**AGENDA
TECHNICAL REVIEW COMMITTEE
REGULAR MEETING
MARCH 12, 2020
9:00 AM
CITY HALL COMMISSION CHAMBERS
204 ASH STREET
FERNANDINA BEACH, FL 32034**

6.1 **SPR 2020-01 - Heirloom Yard**, 20 S. 10th Street: Asa Gillette, Gillette & Associates

The Heirloom Garden

C.O.F.B. Project:
SPR 2020-04

DRAINAGE NOTES

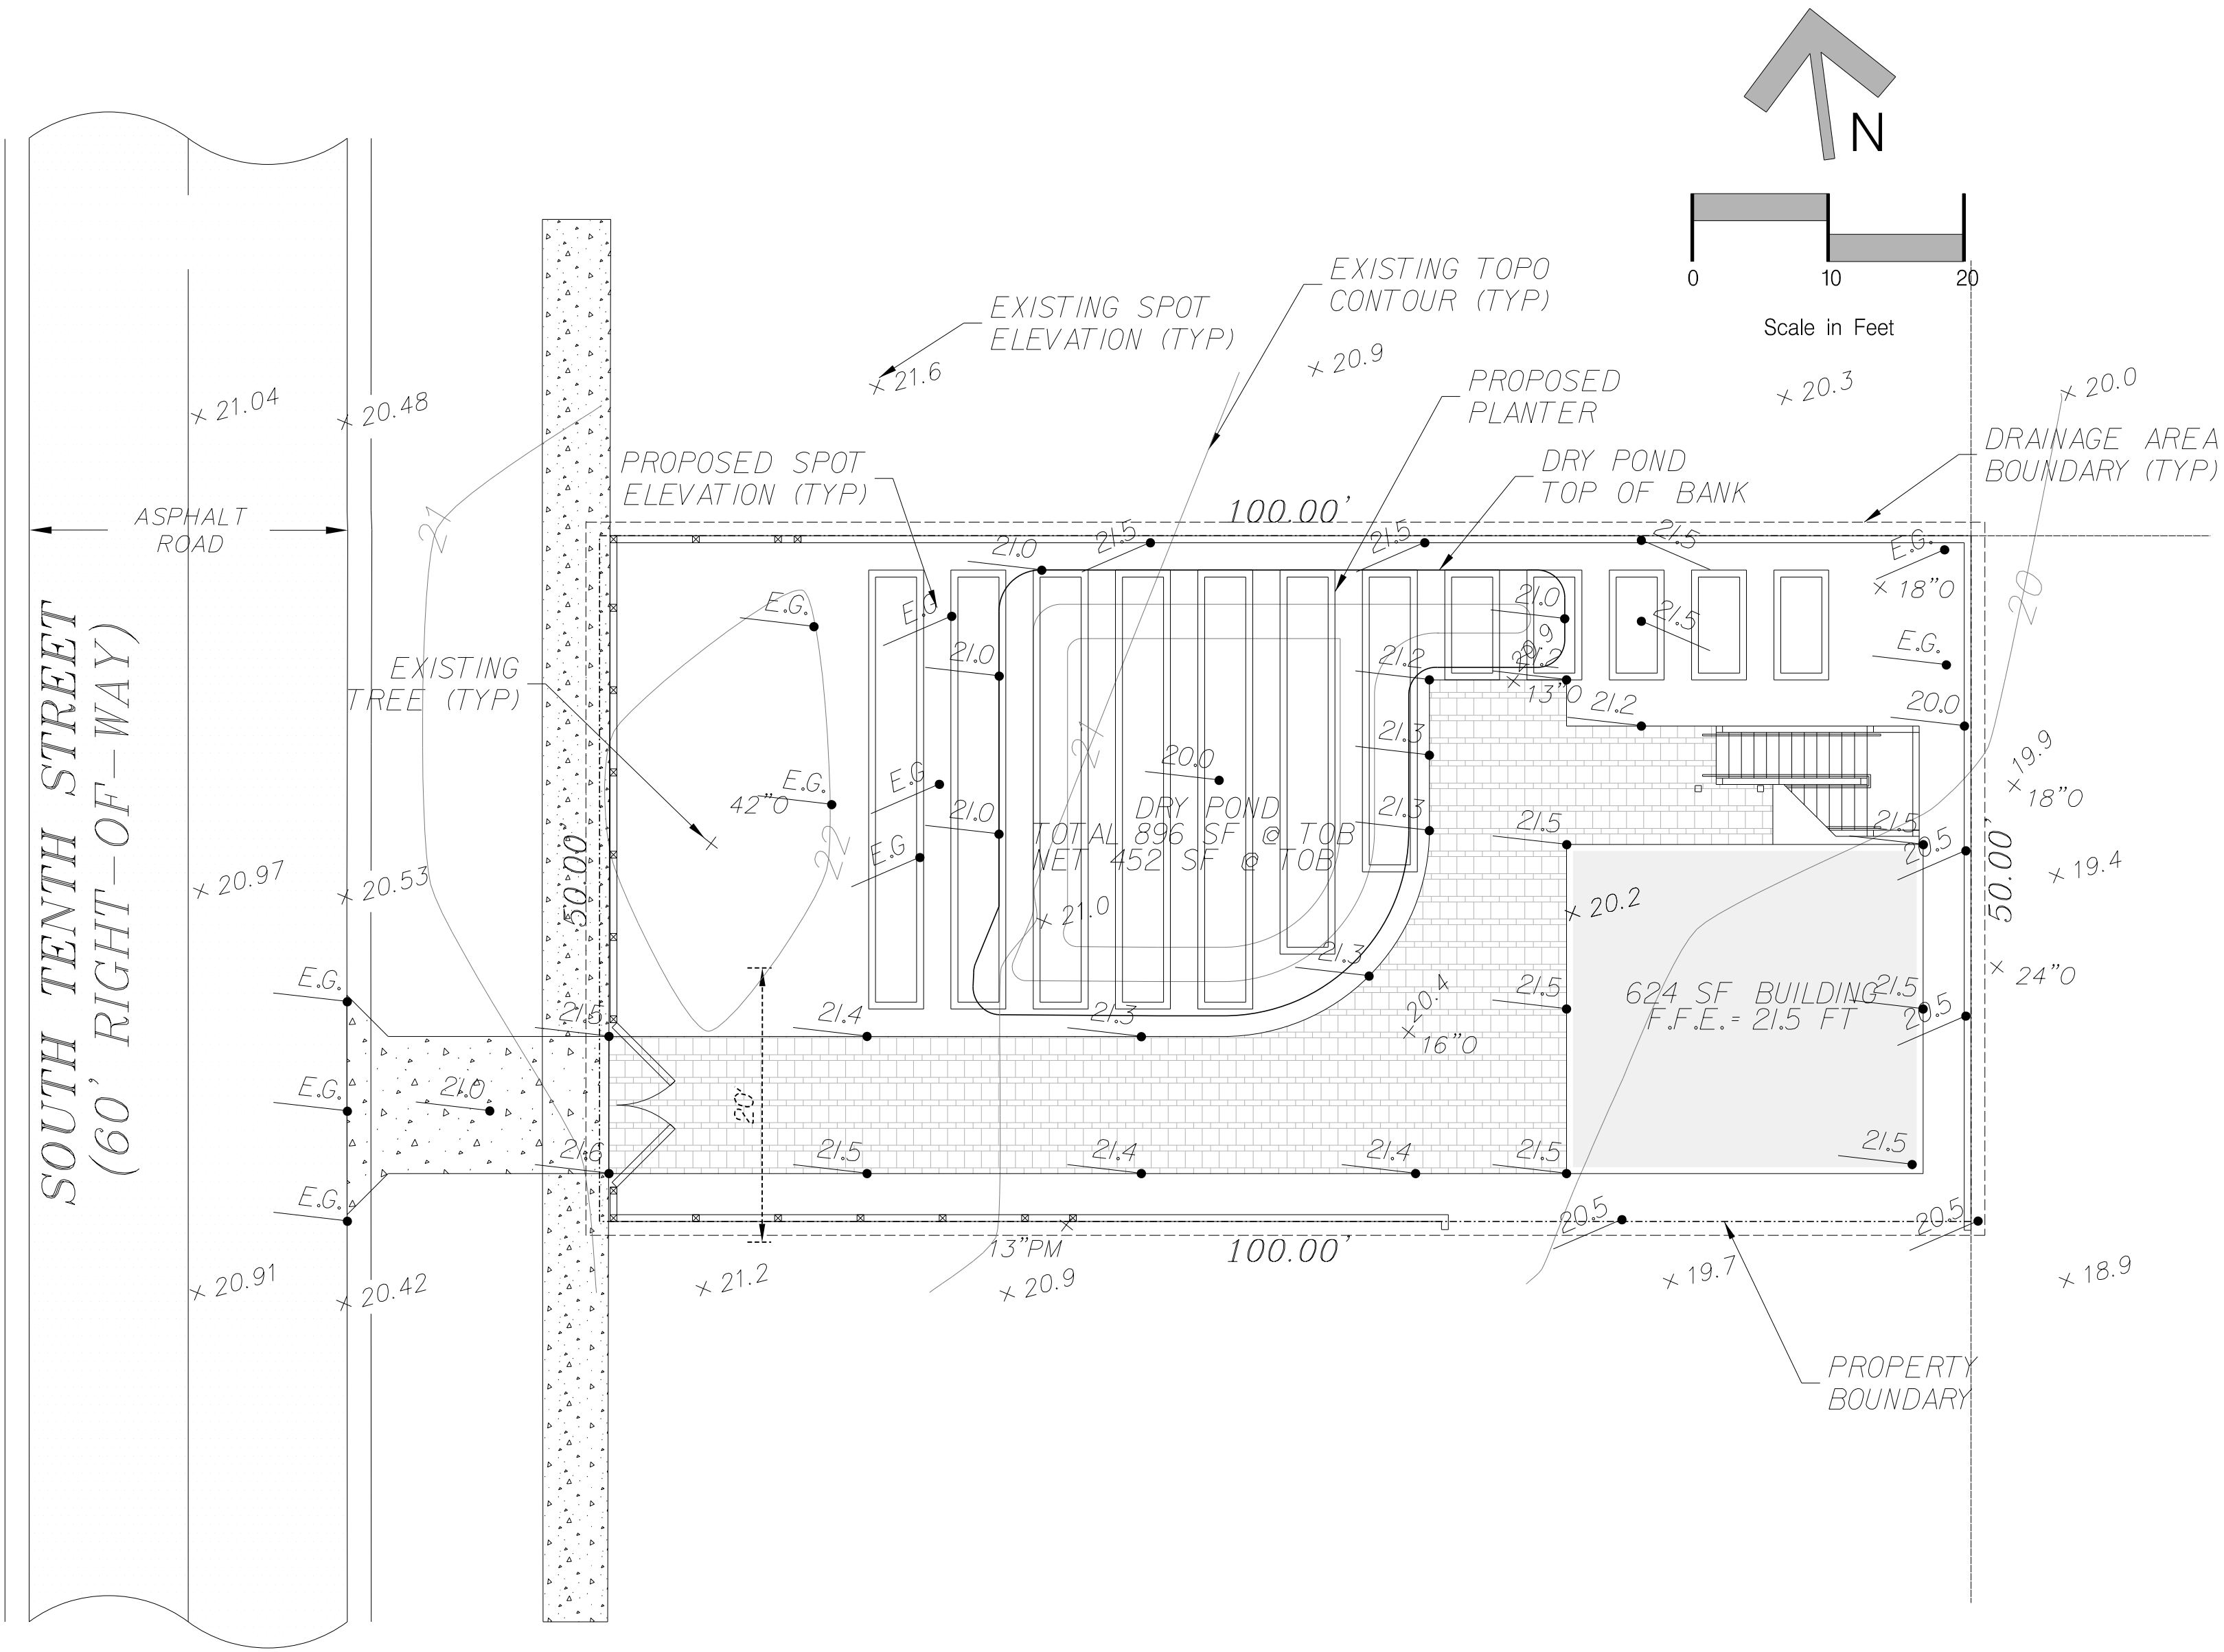
- Section 7.03.03(D) requires that all commercial developments are required to provide detention of the 10yr-24-hour storm event and pre vs post analysis. Please provide calculations demonstrating compliance with this section, as well as SJRWMD or FDEP environmental resource permit or verify exemption.

TREE PRESERVATION NOTES

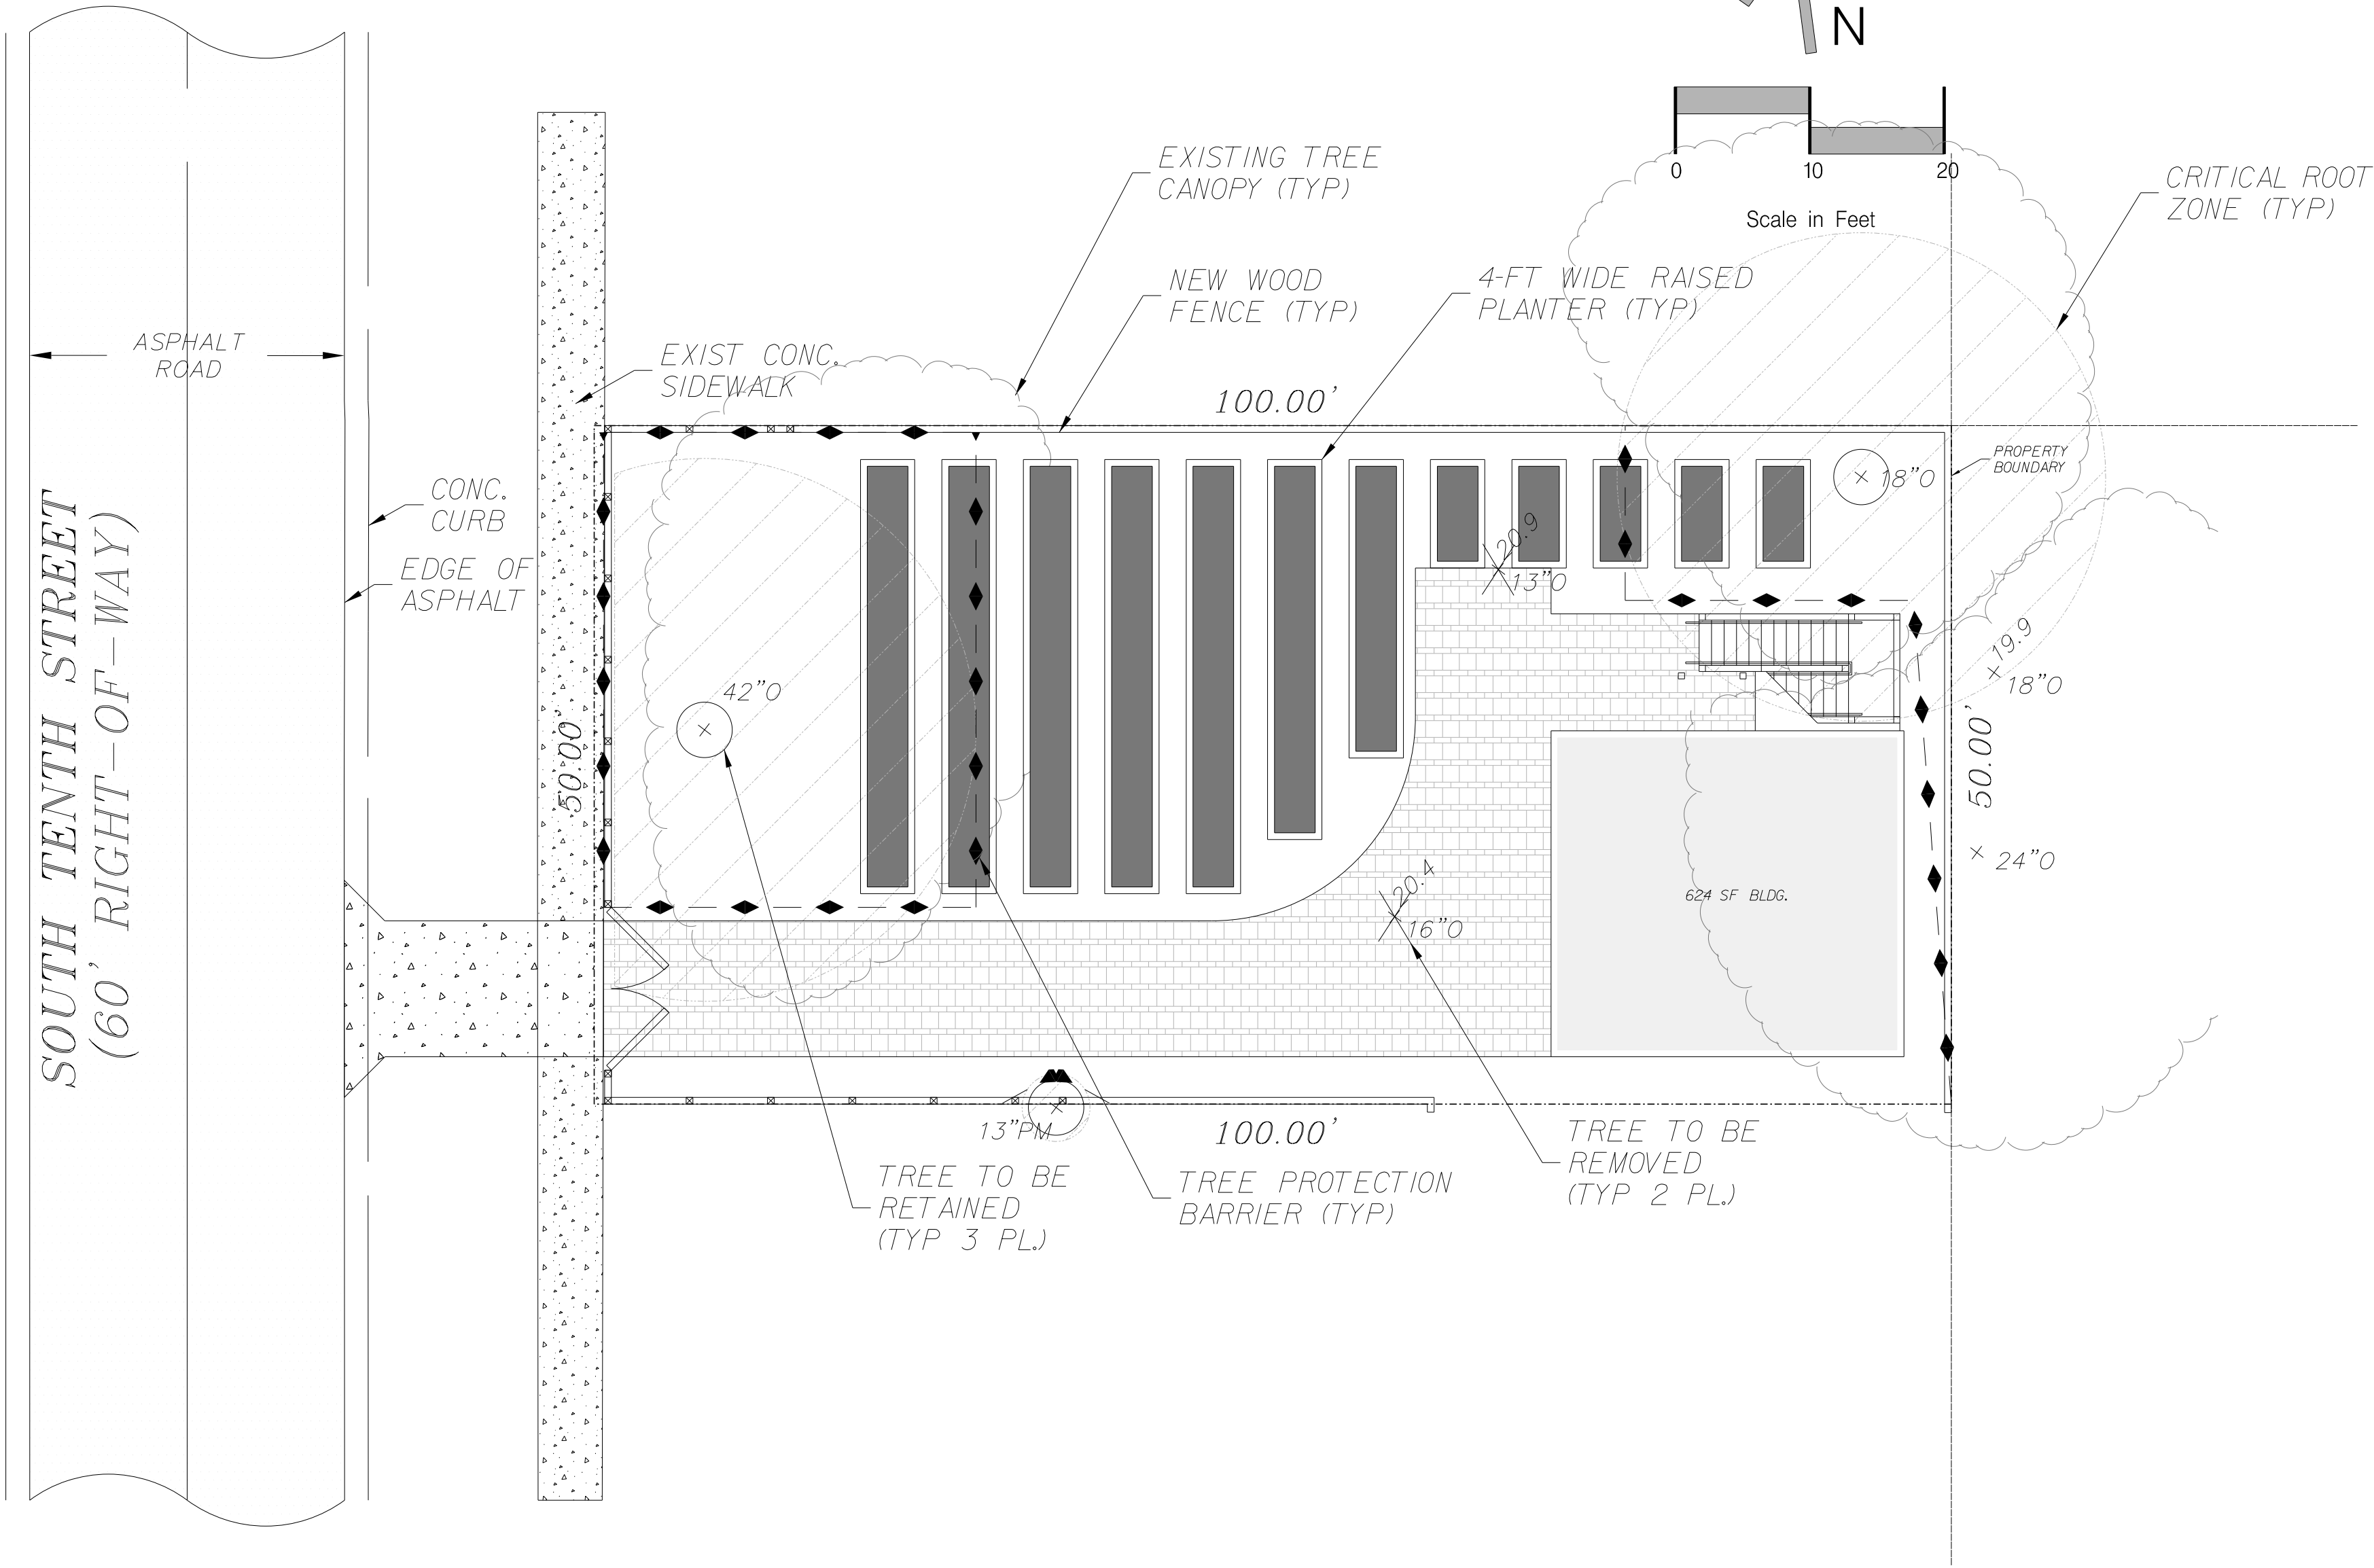
- Please provide a statement on the plans from a certified arborist attesting to the health of the retained trees and their compatibility with the proposed development.
- Please provide a graphic on the tree preservation sheet depicting the typical tree barrier for compliance with 4.05.14(F)(2)(d).
- Is a freestanding sign planned? If so, consider showing location.
